# Assessment of Dam Safety

## Coal Combustion Surface Impoundments (Task 3)

American Electric Power

Big Sandy  
Generating Station

## Big Sandy Piezometric Pressure Head

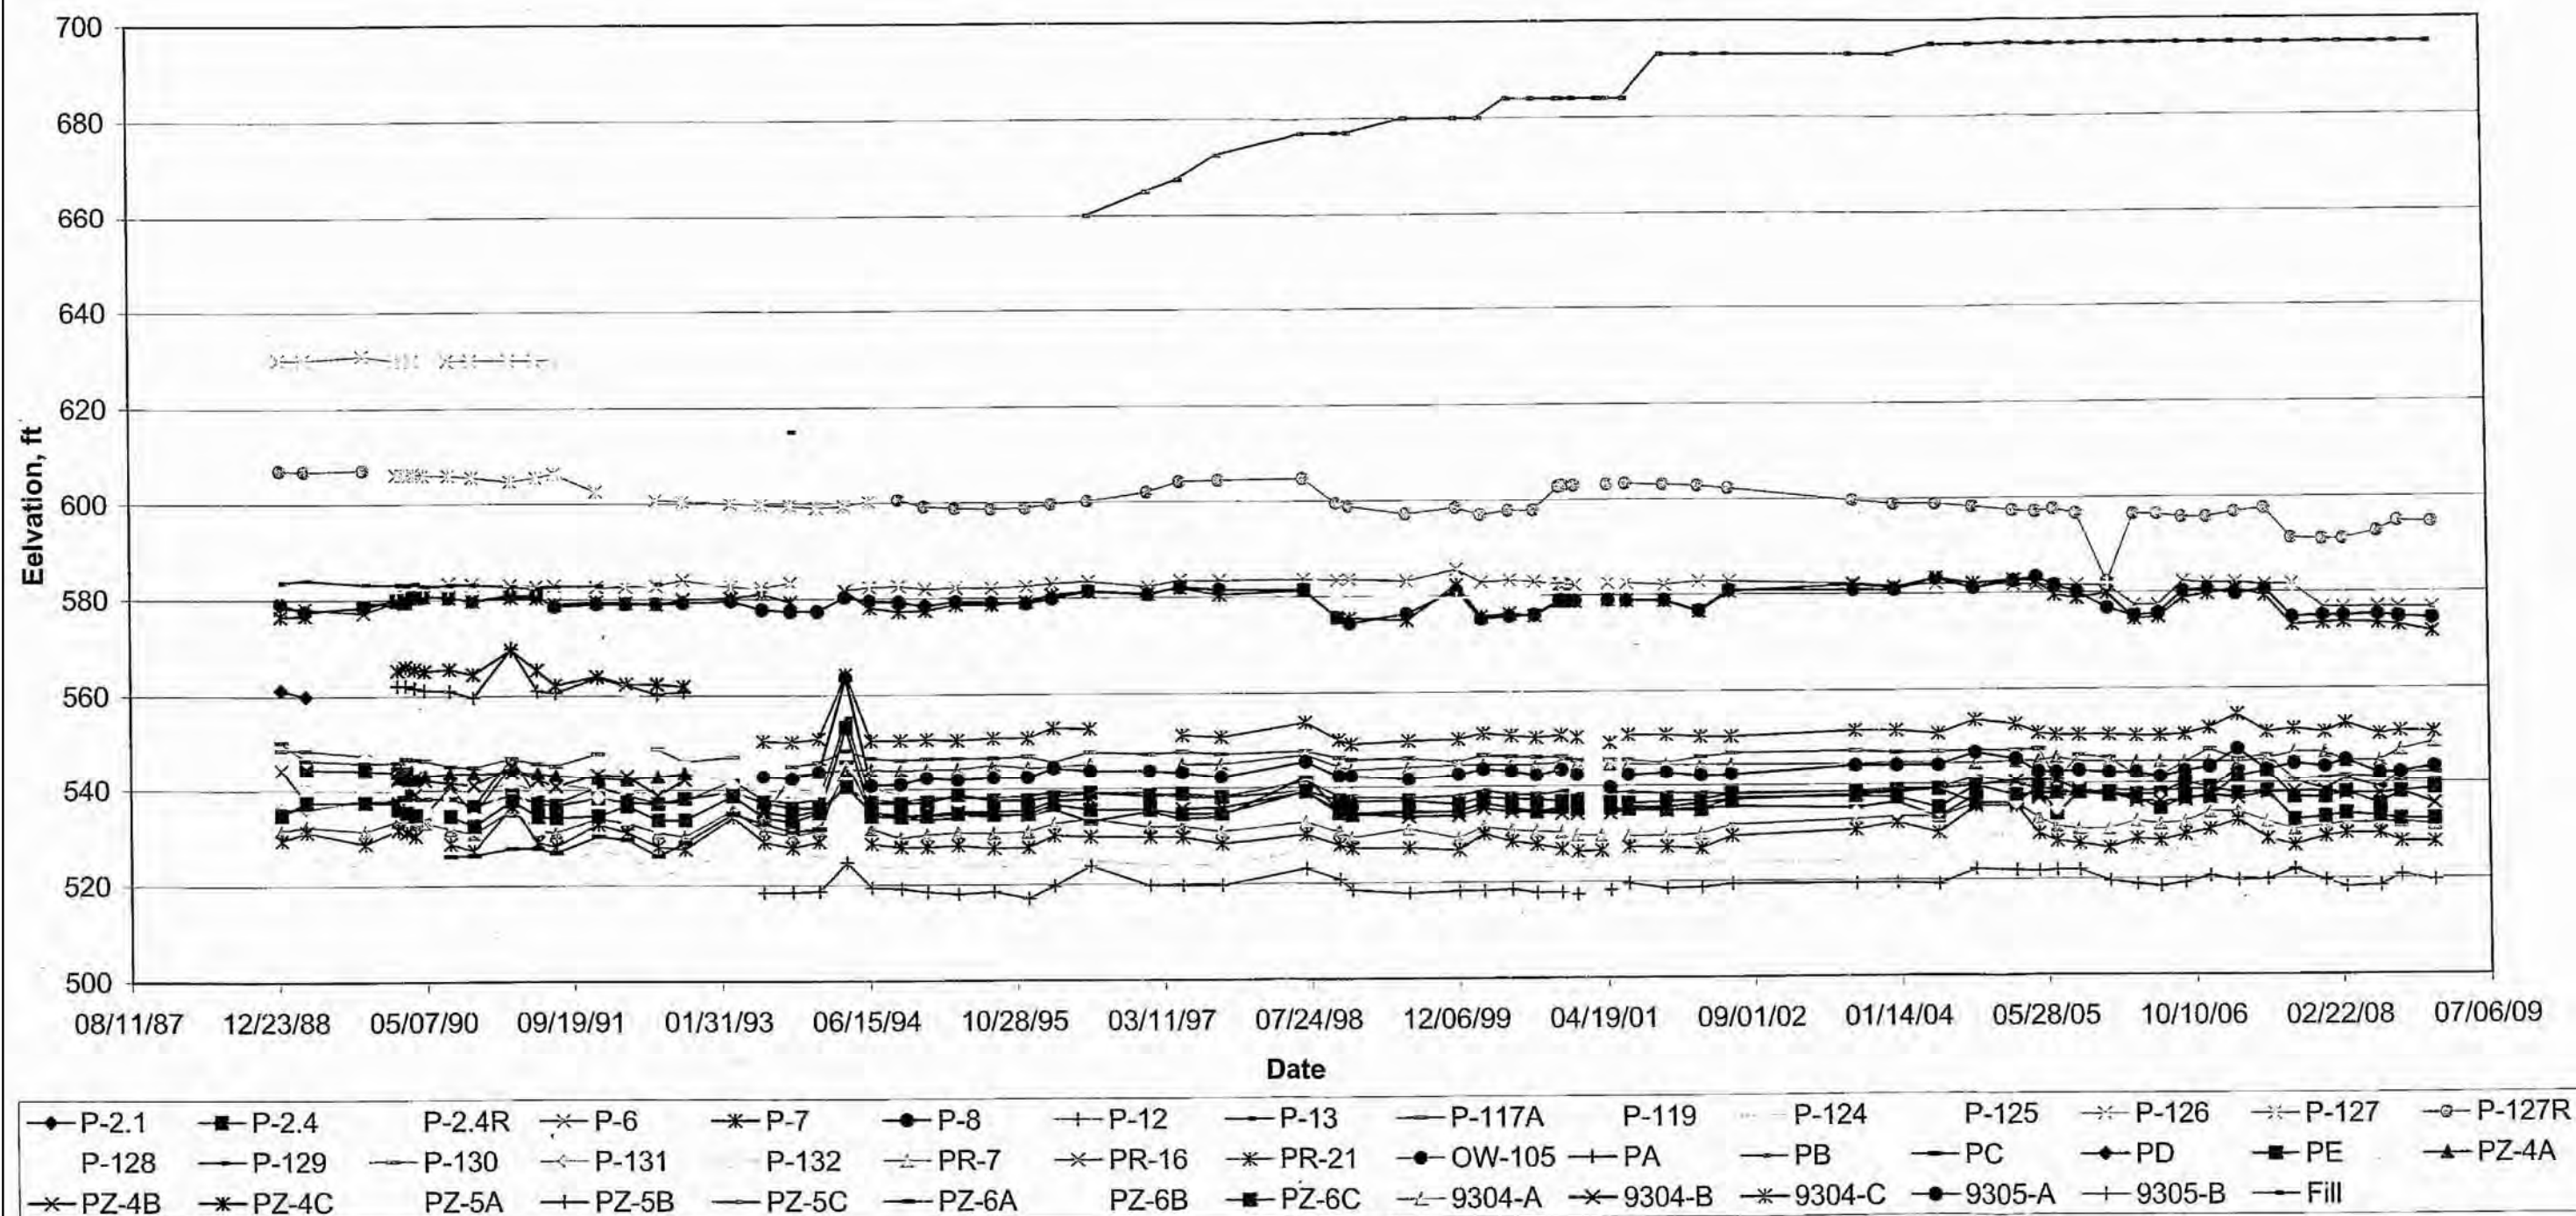
presented in Stantec's 2009 report, we understand that 19 of the 27 piezometers are operational. Figure 8 presents a plot of the piezometer data from December 1988 through June 2009.

HORSEFORD CREEK DAM INCLINOMETER  
SI-1 DEFORMATION  
BIG SANDY POWER PLANT  
LOUISA, KENTUCKY

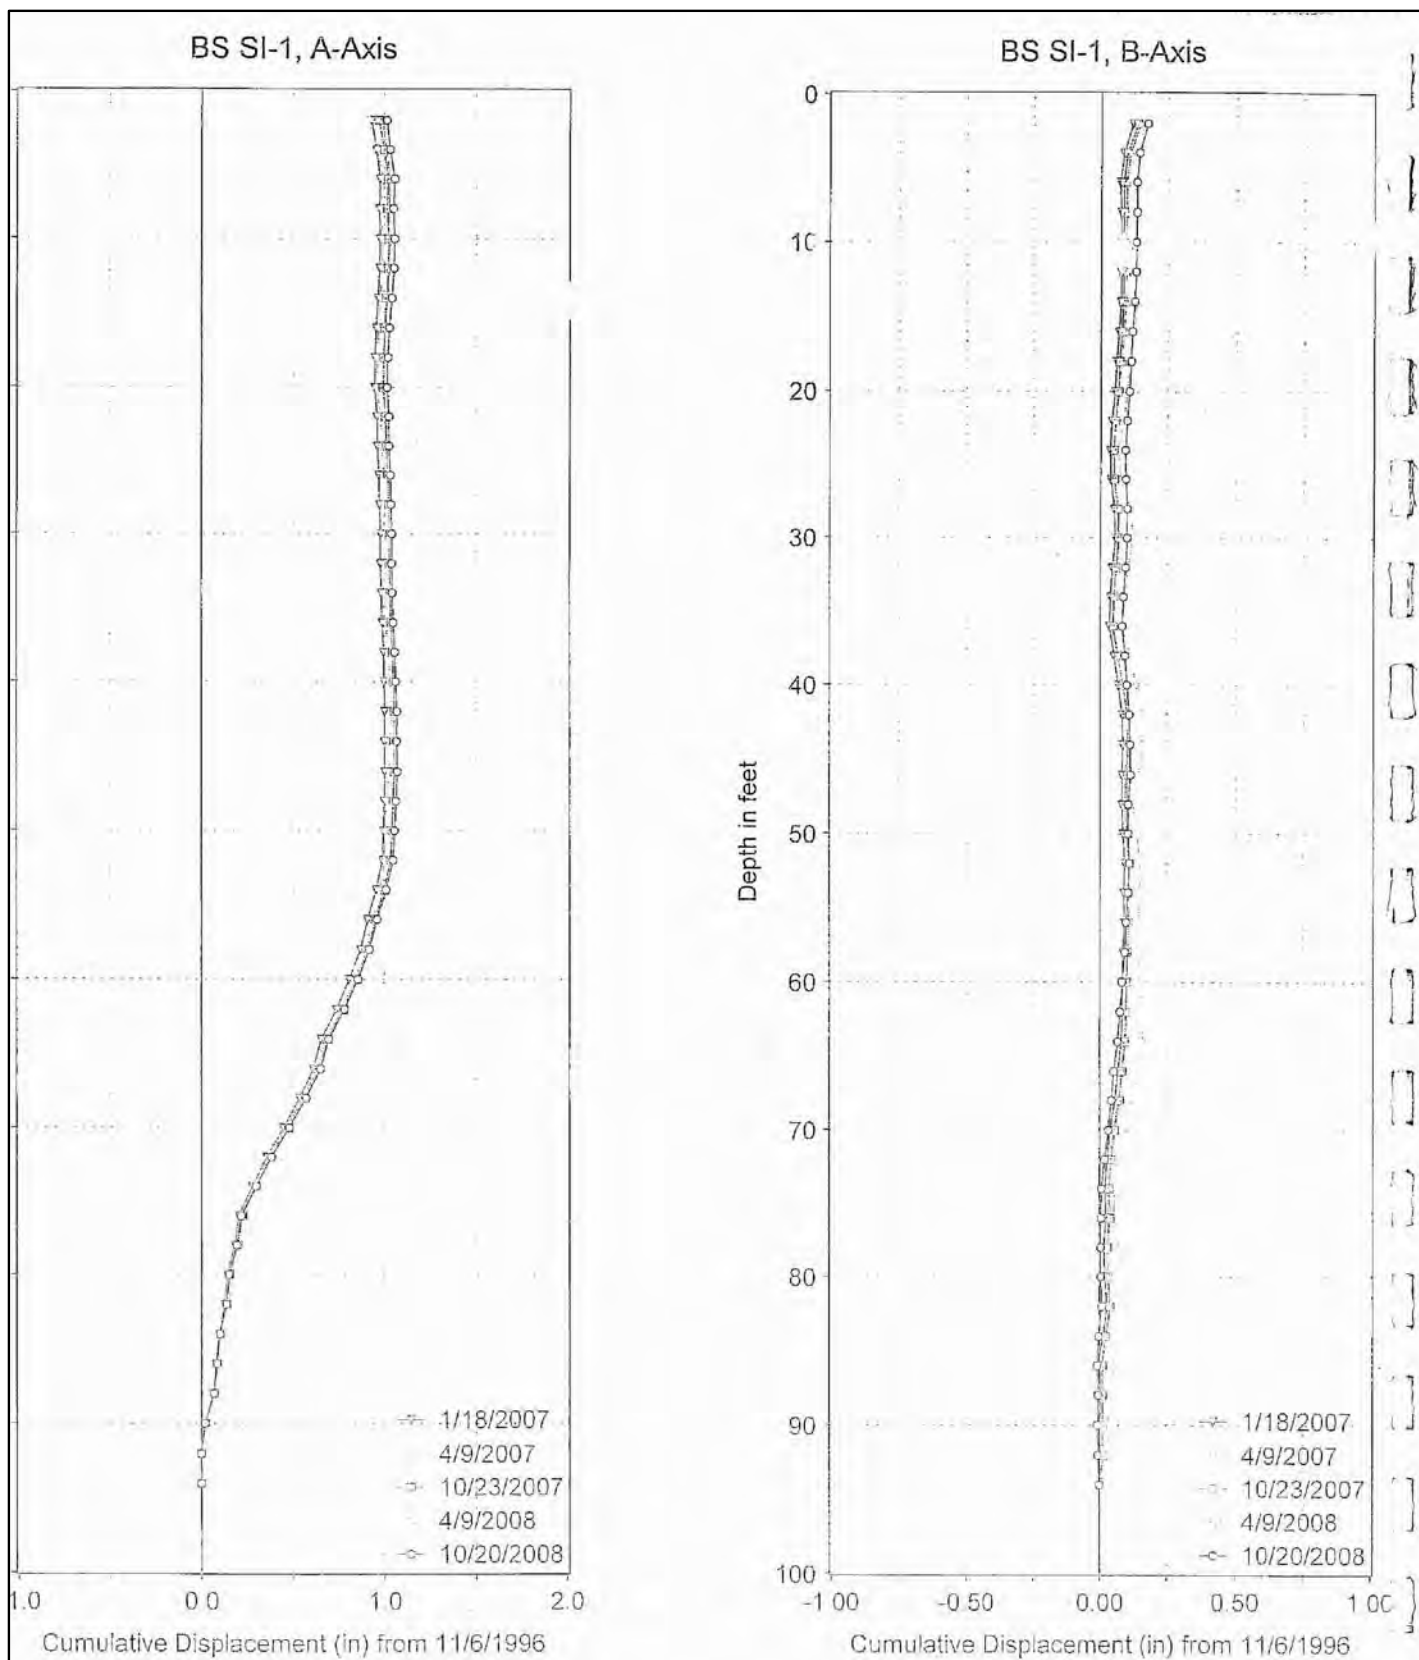
Inclinometer SI-1 is located in the crest of the berm at El. 590; a cumulative deformation plot is included in Figure 12A. The maximum movement in the downstream direction is approximately 1.07 inches. Inclinometer SI-2 is located on the downstream slope at approximately El. 665; a cumulative deformation plot is included in Figure 12B. The top of this instrument was struck by a bulldozer during a previous construction period resulting in the large displacements between El. 631 and 611 within the embankment fill indicated on the plot on Figure 12B. Accounting for this damage, AEP (2008) reported that the maximum movement in the downstream direction is approximately 1.04 inches.

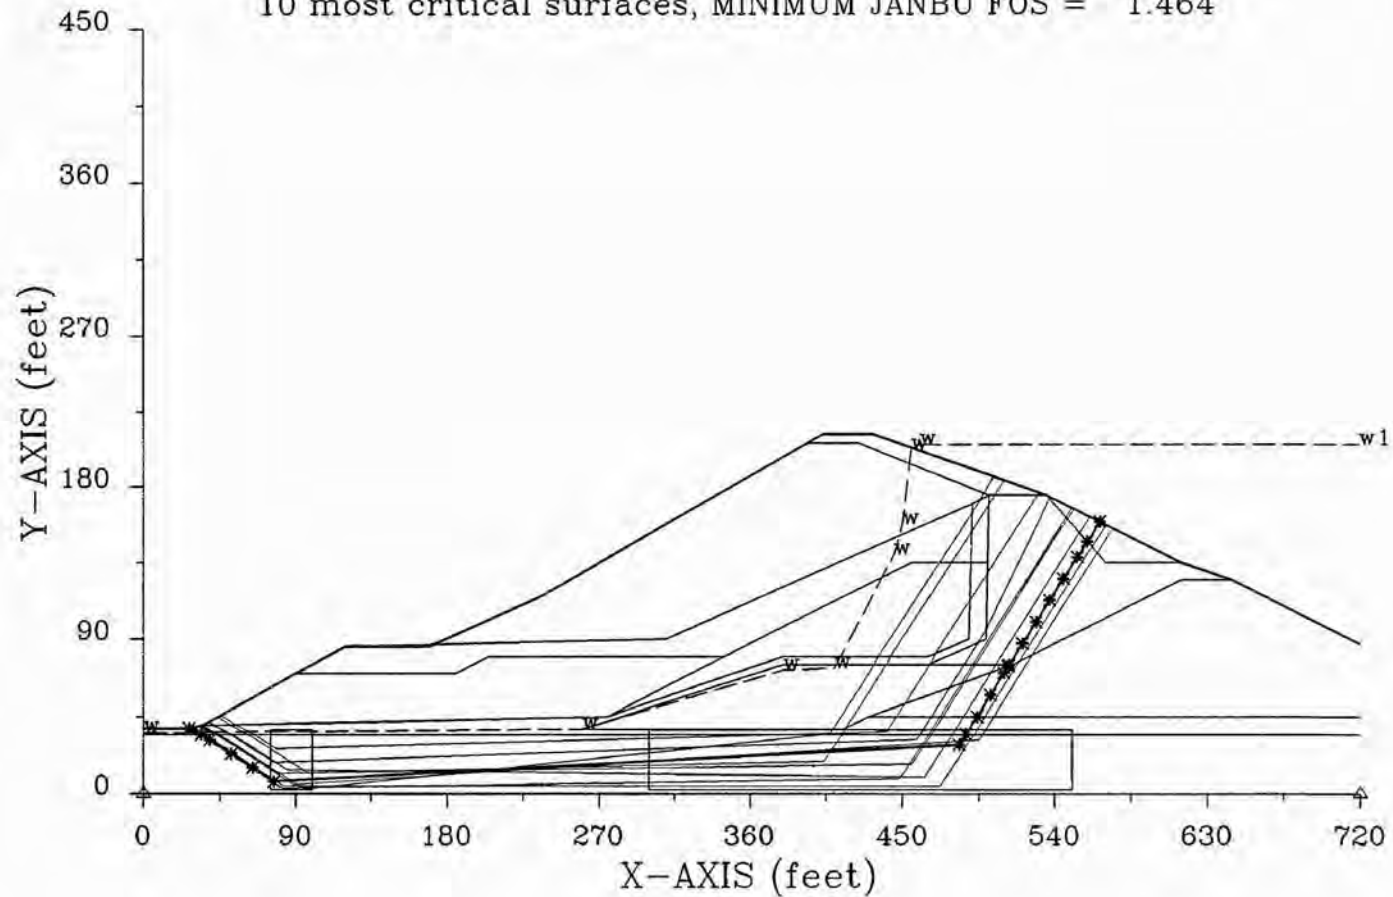
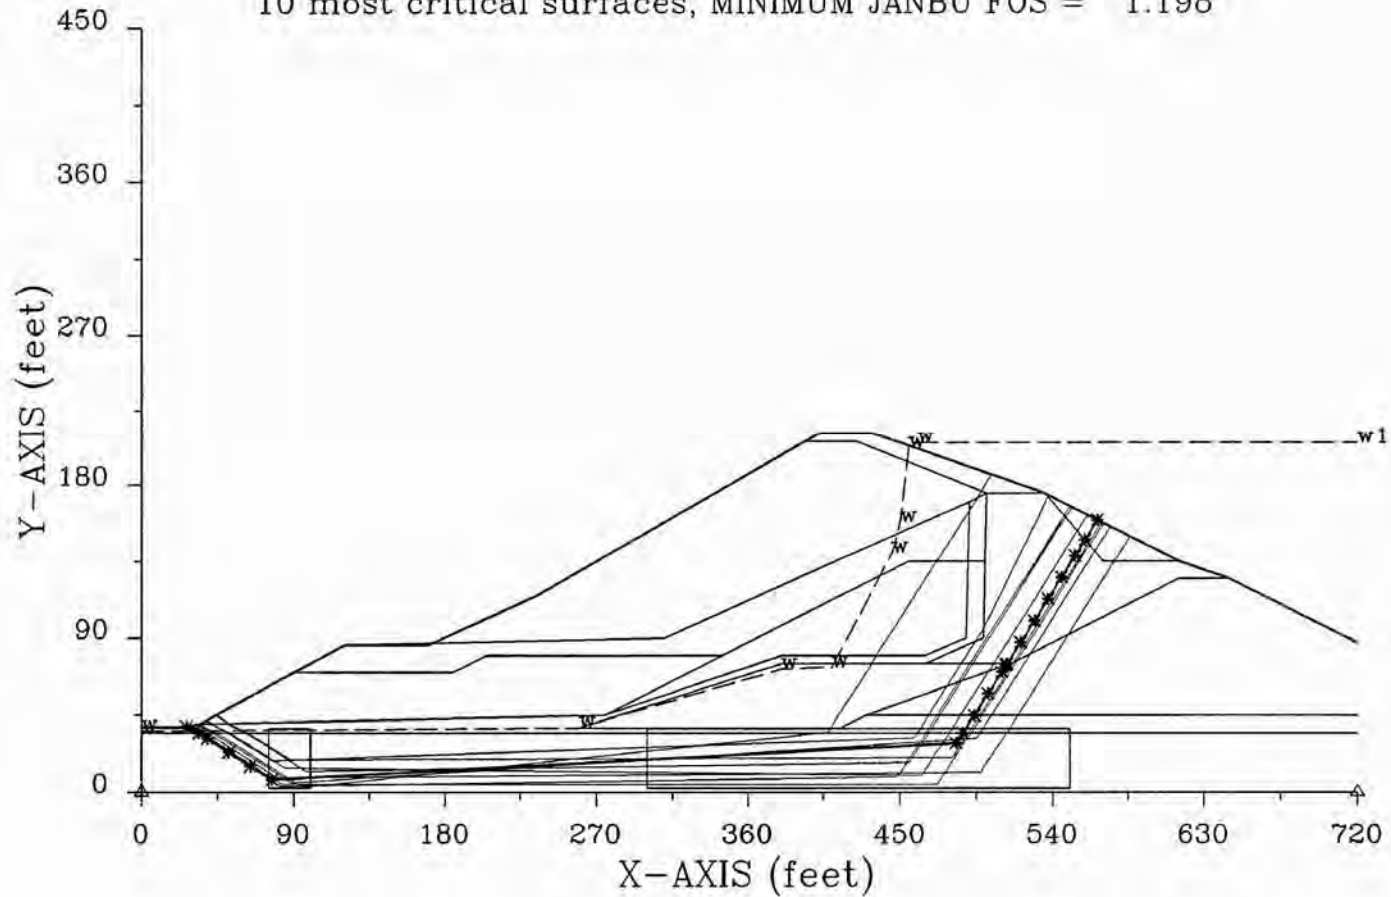
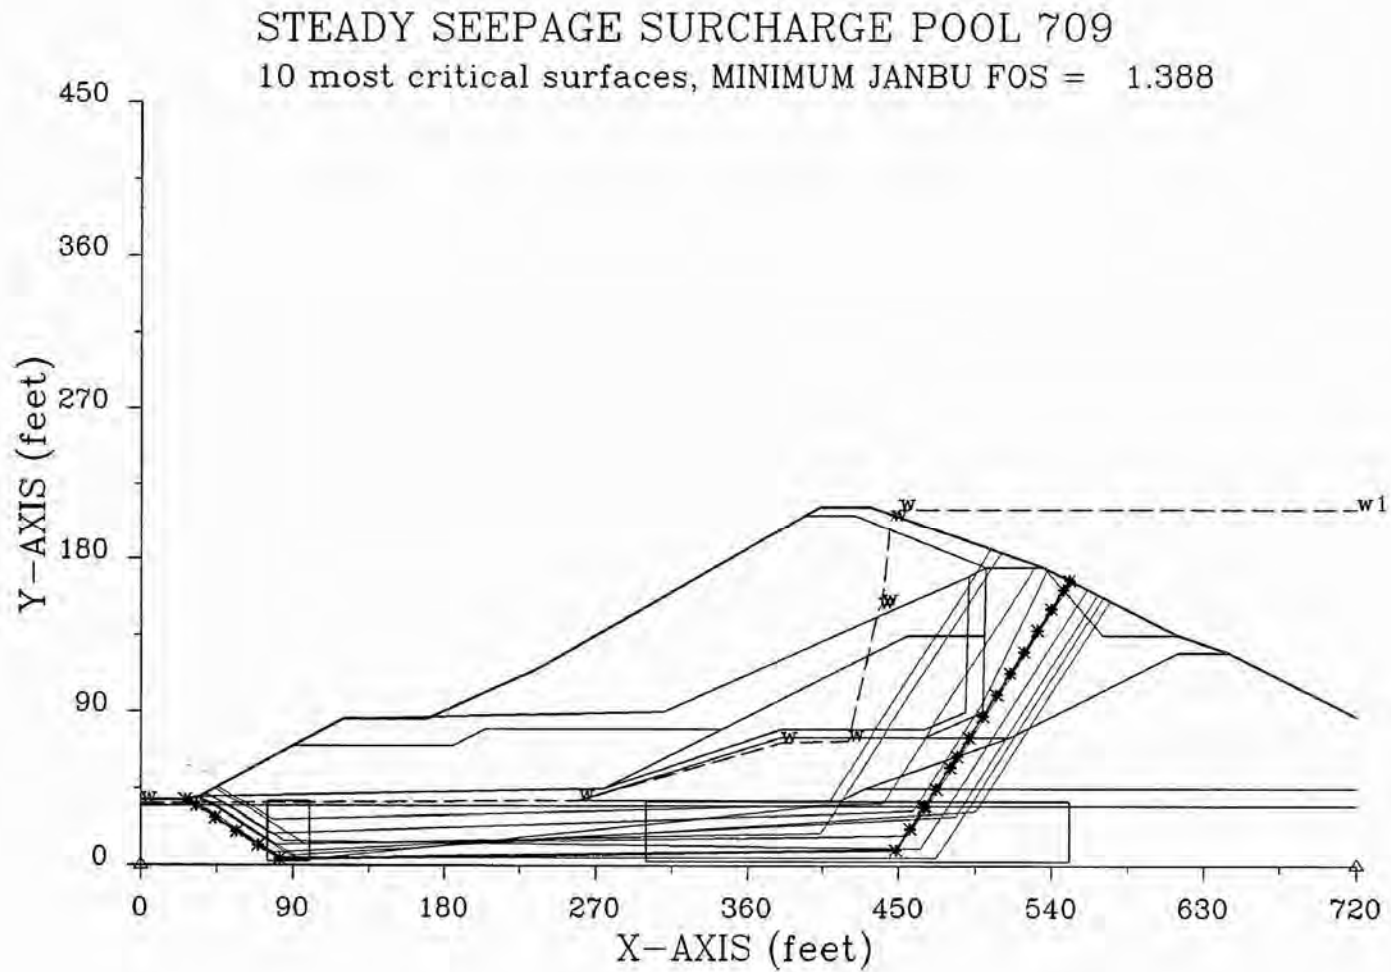
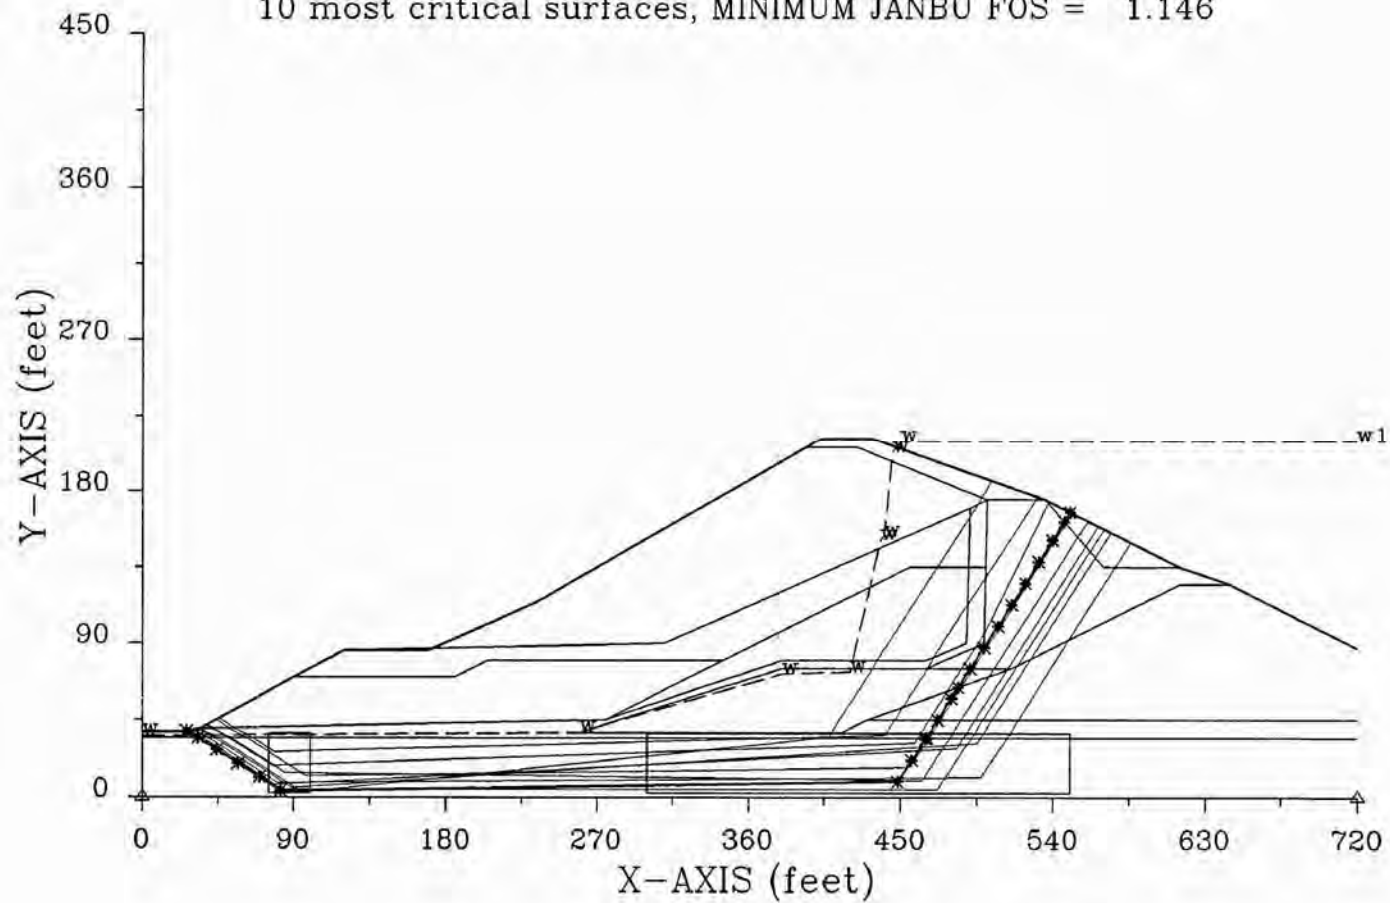
appendix to AEP's report. The computed factor of safety is lower in the December 1992 results; unfortunately a discussion regarding the difference in the two sets of analysis is not presented in the report. For a typical section of the embankment the AEP December 22, 1992 analyses resulted in the factors of safety summarized in Table 7. Figures 13A through 13F show the stability analysis cross sections. AEP indicated that use and operation of the Fly Ash Pond precluded development of a rapid draw down condition, therefore a stability analysis was not performed.
